ADDENDUM NO. 1

PROJECT: WILLIAMS CHARTER TOWNSHIP
S. GARFIELD TO W. FISHER ROAD WATER MAIN
AND SANITARY SEWER

DATE: JULY 30, 2025

WAK PROJECT NO. 25-1247- 0021

SHEET
C2.0

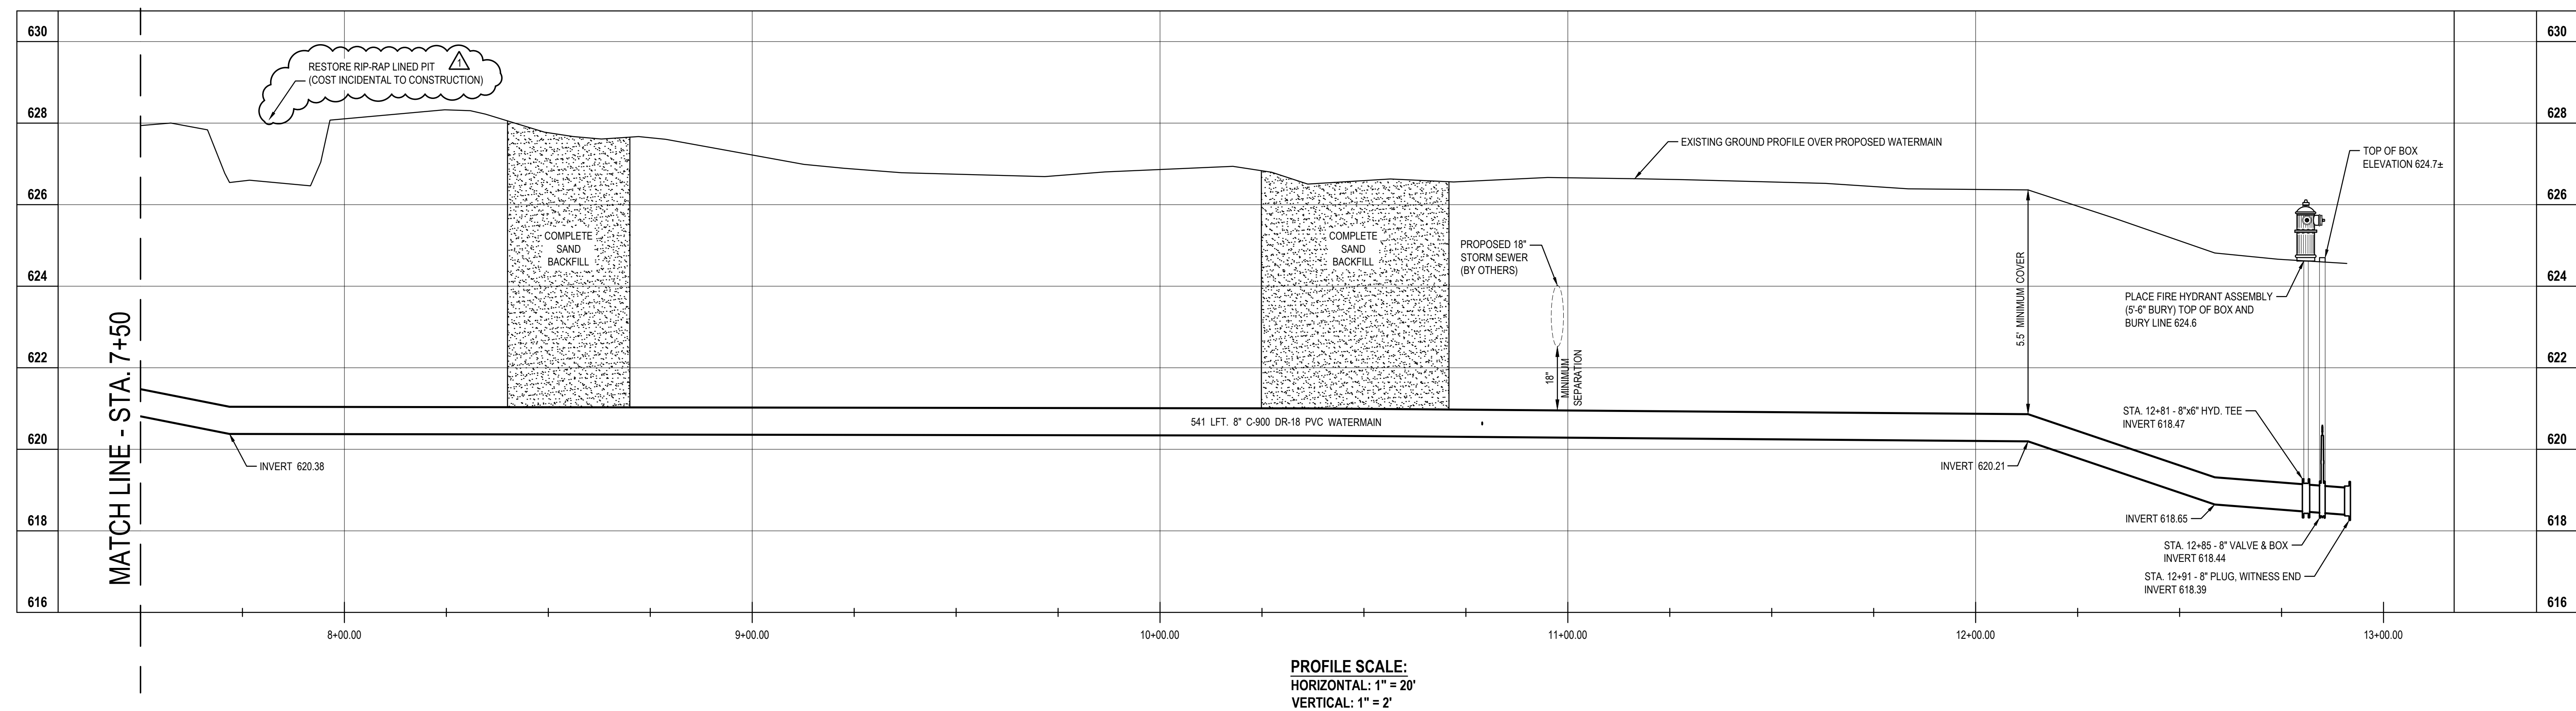
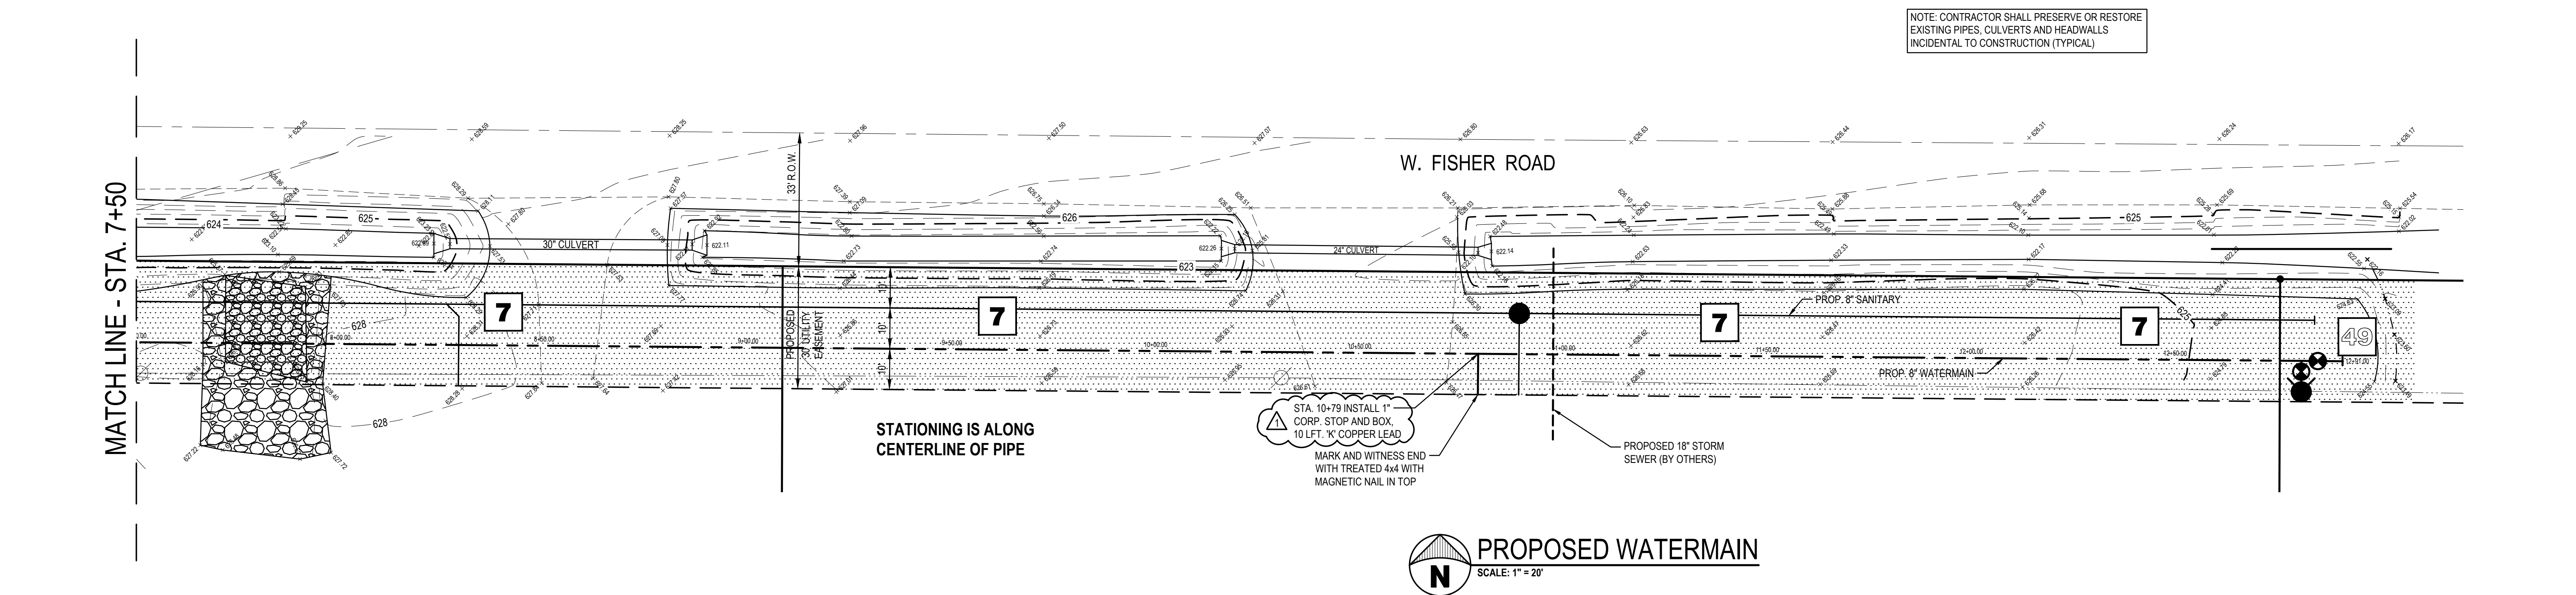
1. **Re-issued Drawing C2.0:** Please note benchmark change/clarification. Applies to all plan sheets.
2. **Re-issued Drawing C3.1:** Please note added 1" water service lead at Sta. 4+24.
3. **Re-issued Drawing C3.2:** Please note added 1" water service lead at Sta. 10+79, and restoration of existing rip rap is called out as "incidental to construction".
4. **Re-issued Drawing C4.0:** Please note removal and replacement of existing south drive to Tri-City Equipment Rental, 5024 Garfield Rd, Auburn, MI 48611.
5. **Re-issued Drawing C4.1:** Please note added 6" sanitary sewer service lead at Sta. 4+65, and restoration of existing rip rap is called out as "incidental to construction".
6. **Re-issued Drawing C4.2:** Please note added 6" sanitary sewer service leads at Sta. 8+90, and Sta. 11+50. Changed manhole rim at Sta. 11+50.

SCALE: 1" = 50'
PROJECT NUMBER: 06-0029
SHEET: **177**

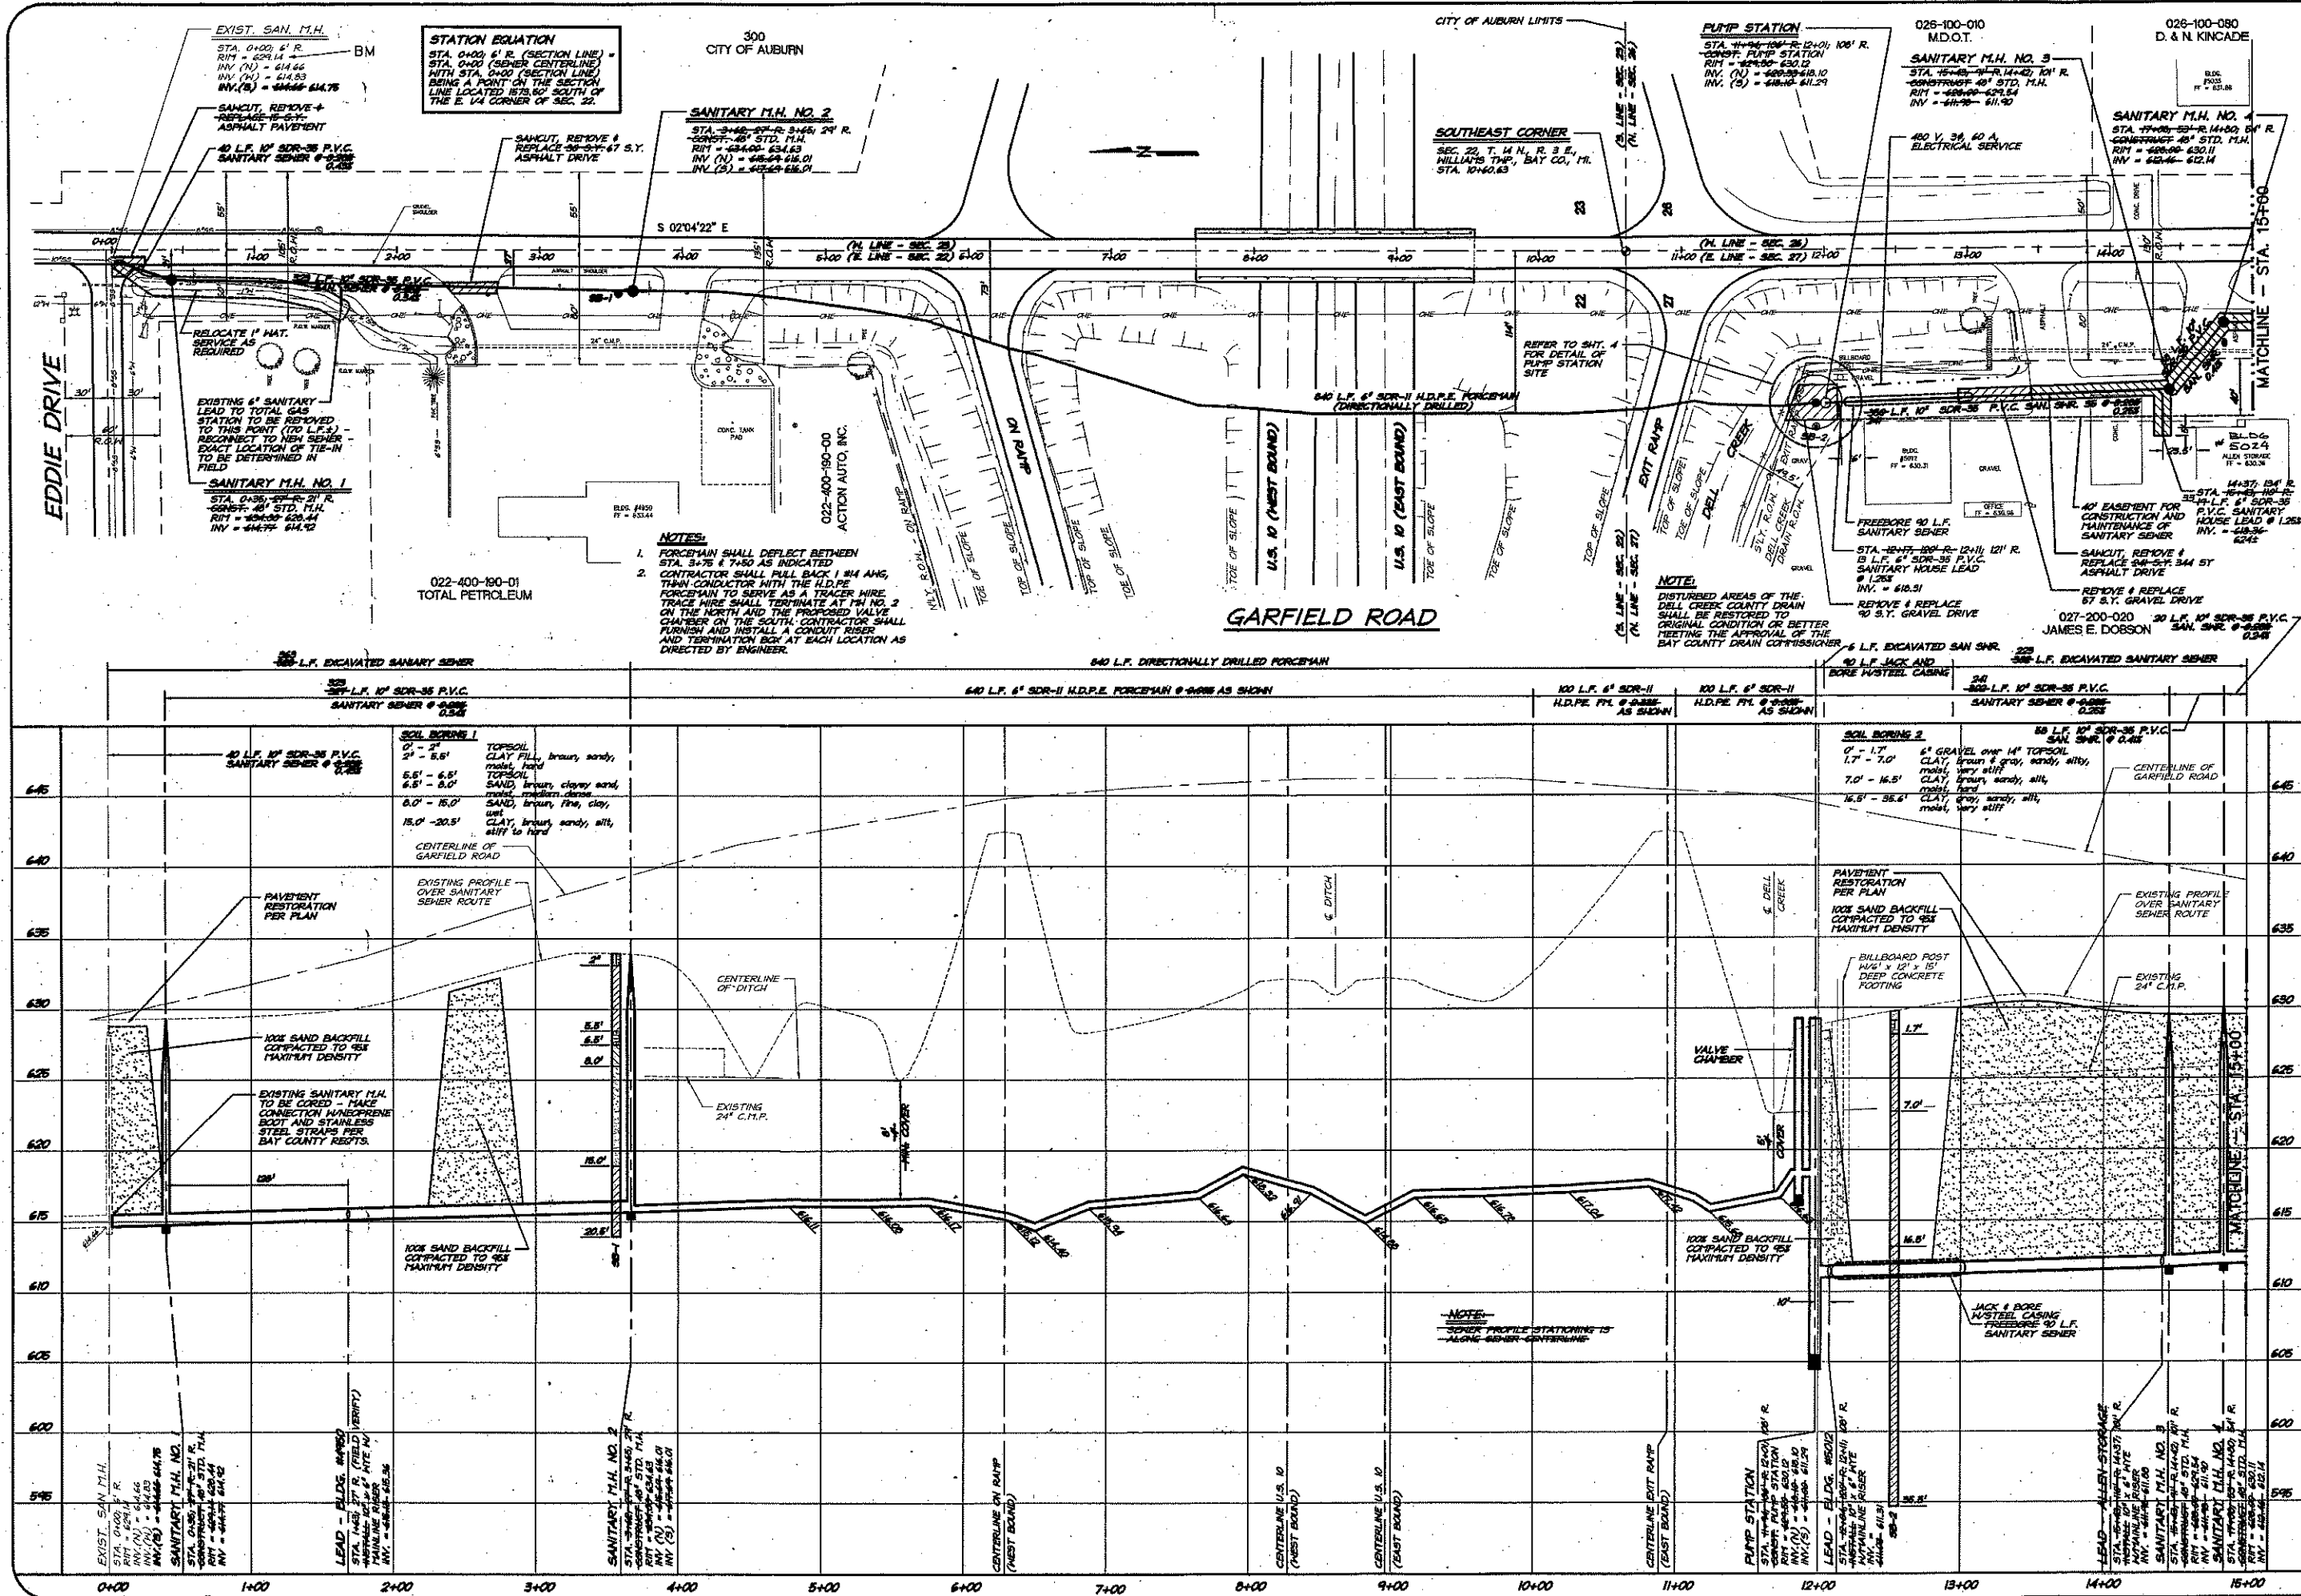
Item #2 – Added reference drawing #177 for existing watermain along the west side of S. Garfield Road.

SANITARY SEWER PLAN/PROFILE	
BAY COUNTY WASTEWATER COLLECTION SYSTEM	
GARFIELD ROAD SANITARY SEWER	
GARFIELD ROAD	
STA. 15+00 - STA. 27+24	
EDDIE DRIVE TO 2724' SOUTH

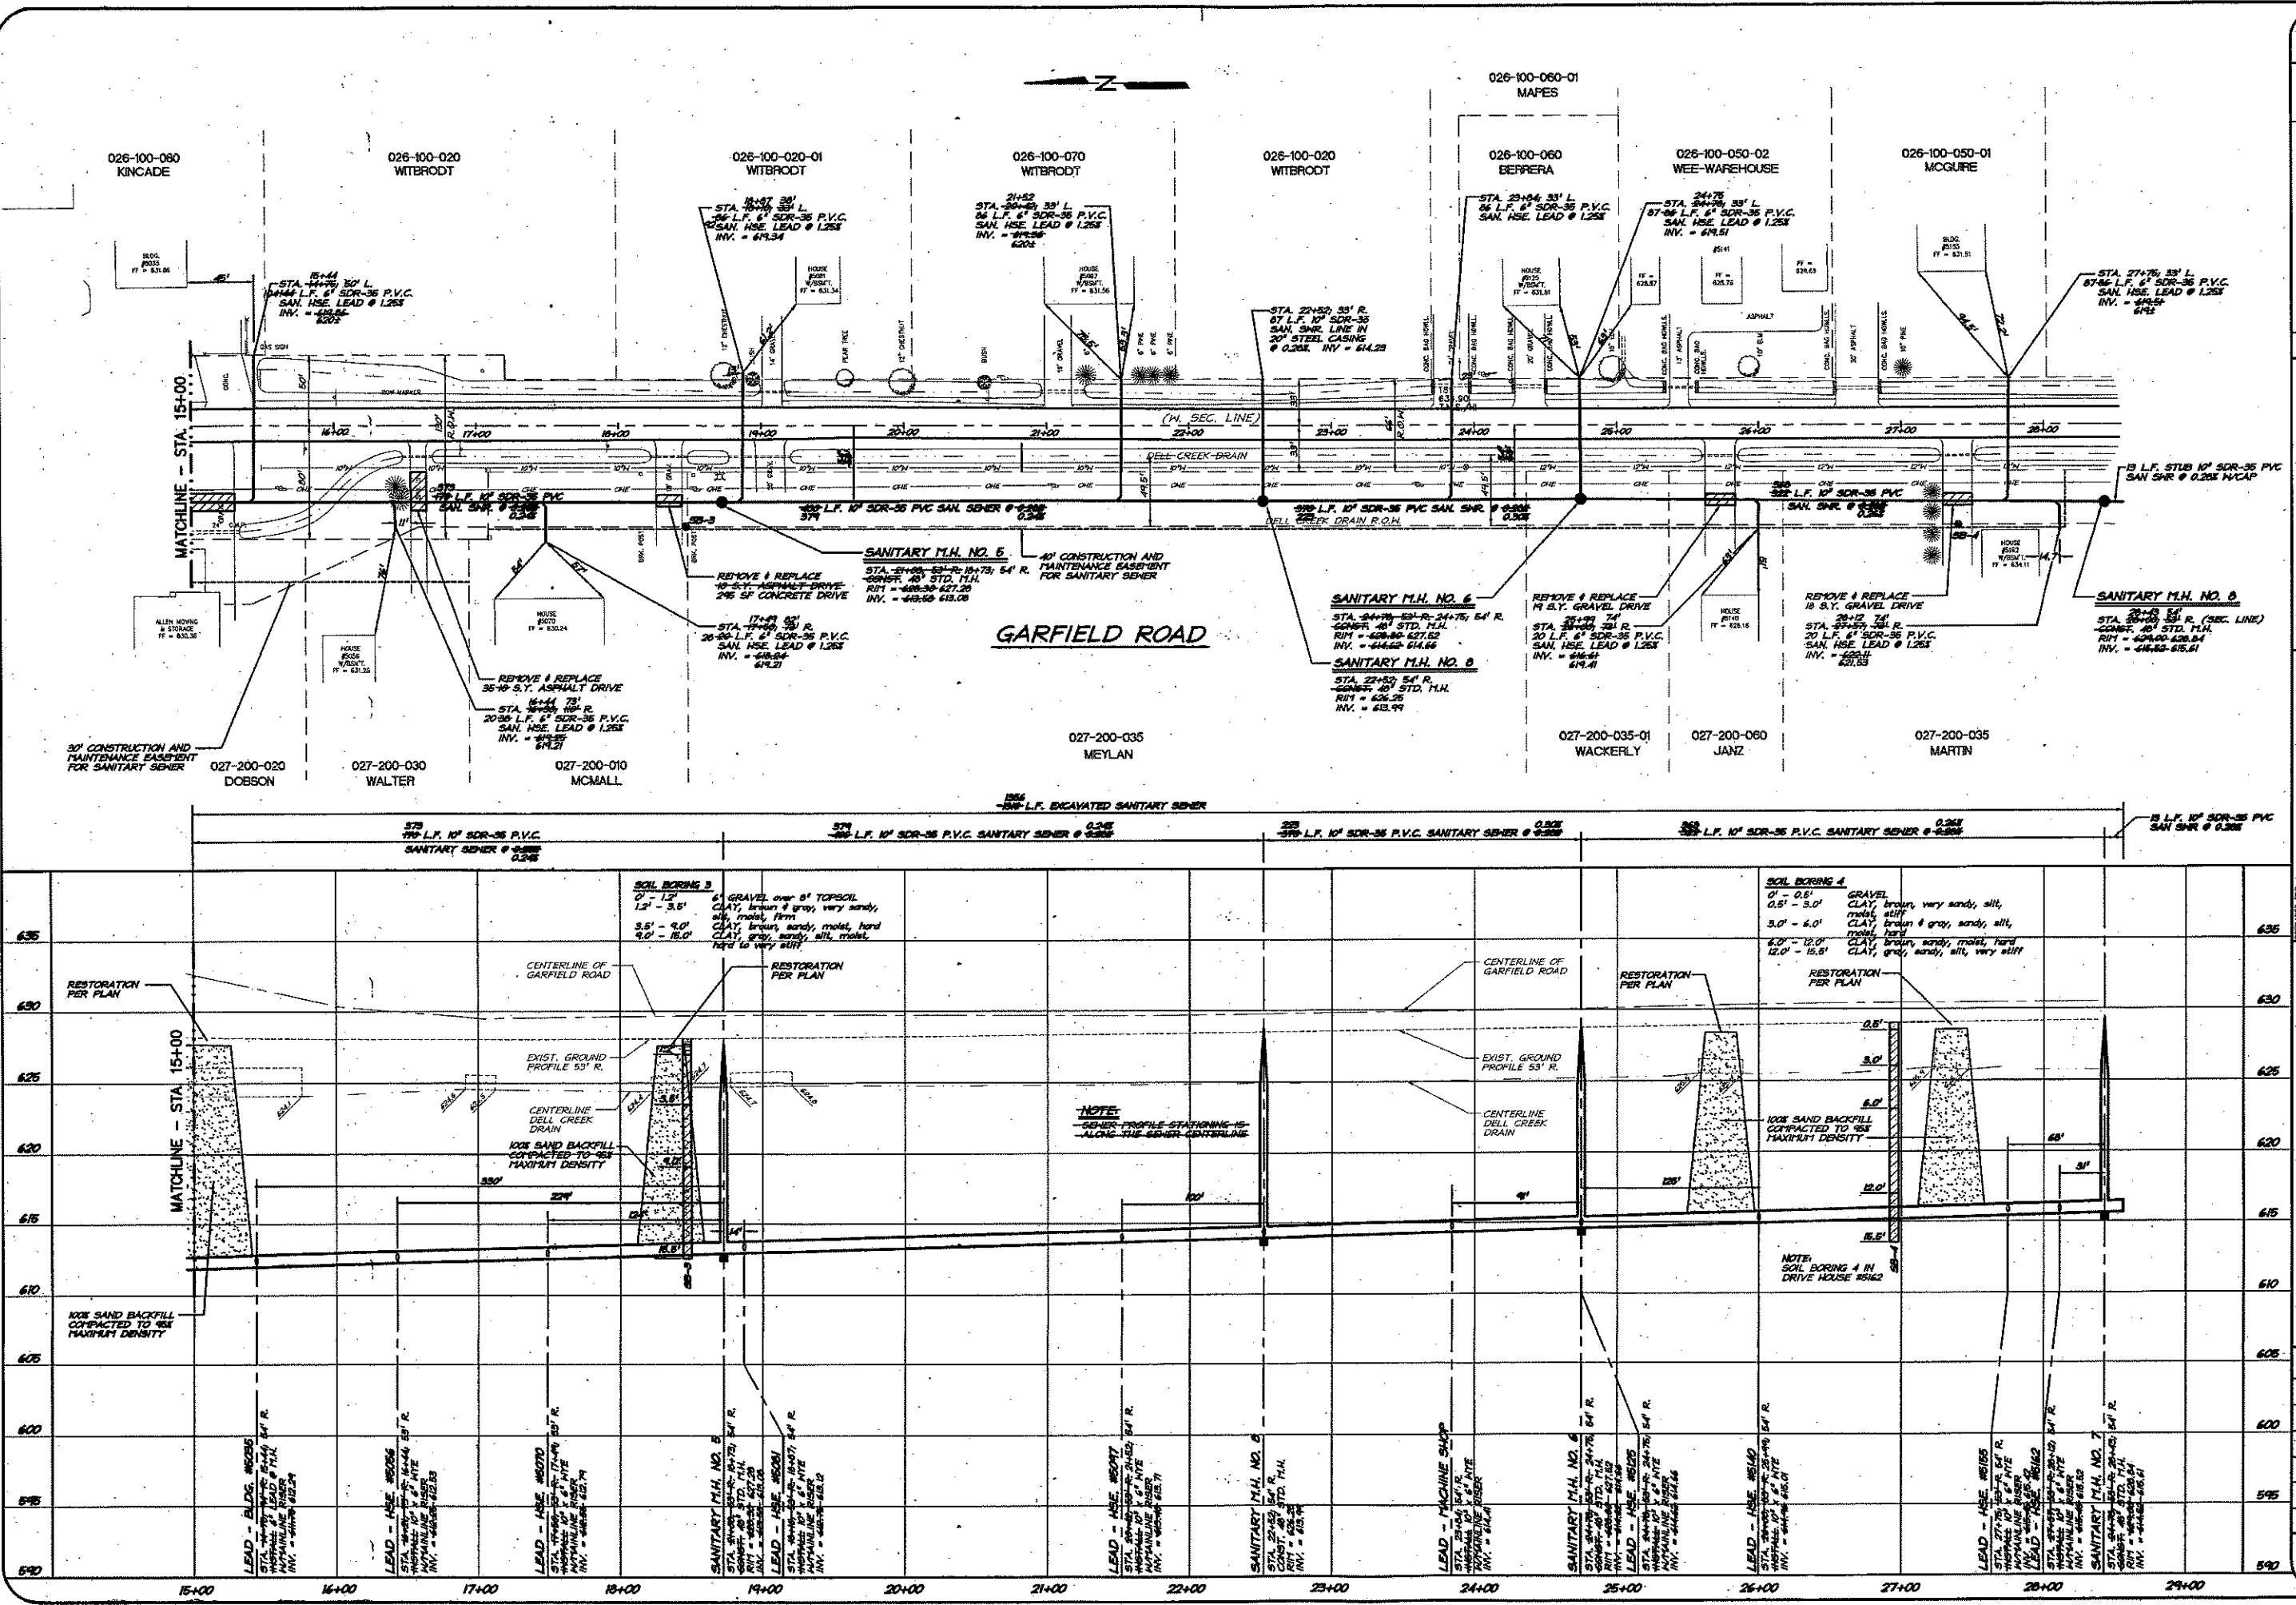
Item #3 – Added reference drawing #68 for existing sanitary sewer along the west side of S. Garfield Road.
